**OFFICIAL MEMO of COORDINATION (MOC) FOR
NON-ROUTINE OPERATIONS & MAINTENANCE**

COORDINATION TITLE- 20 IHR 08 Floating Guidewall Cable Replacement

PROJECT- Ice Harbor Lock and Dam

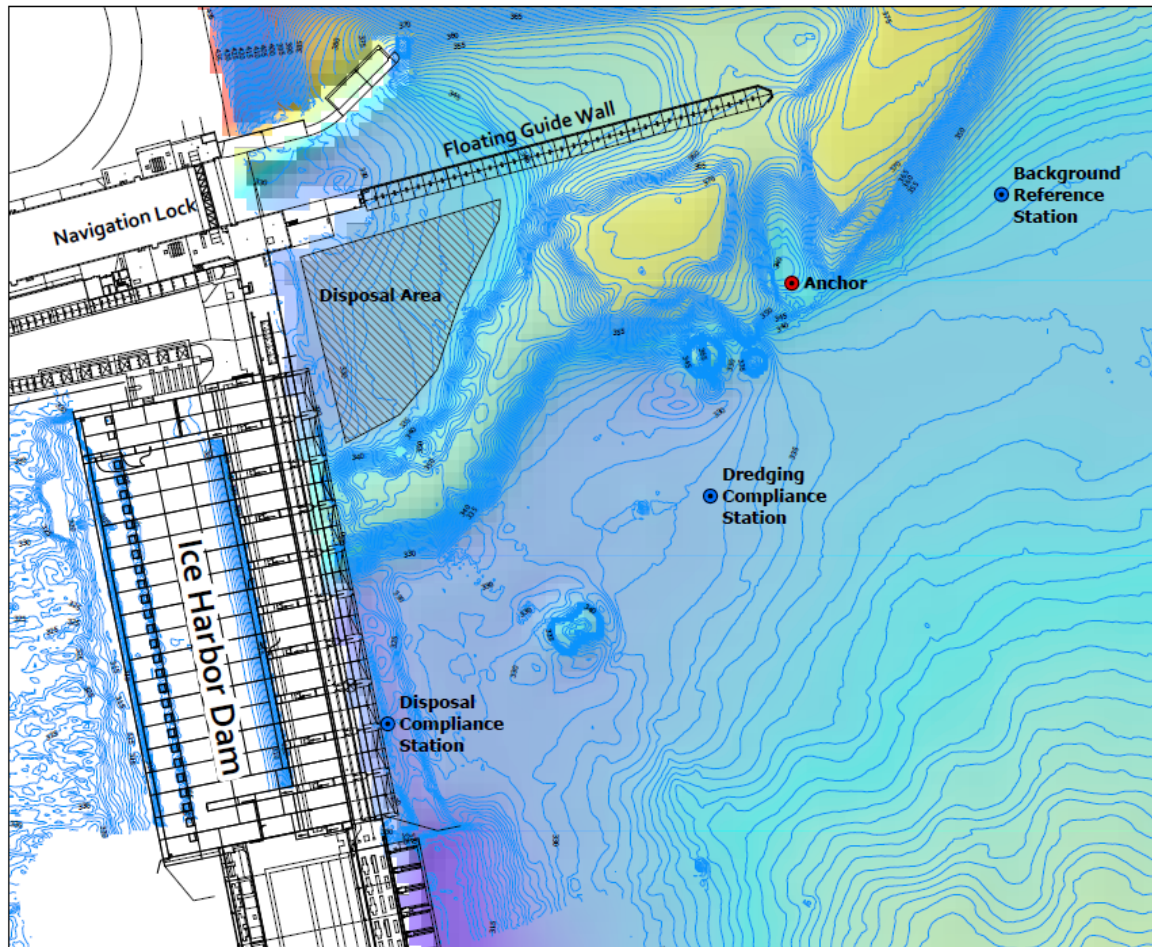
Can we get a map or two before the FPOM meeting on Thursday which includes the location of the suction dredging site(s), how that equipment will be deployed, and also one including the location of the cables that are being replaced in reference to the fish ladder entrances before the FPOM meeting on Thursday? I have a map of the dredging disposal locations already, but I am not finding anything in addition to this.

Per your request, here is the diagram you requested.
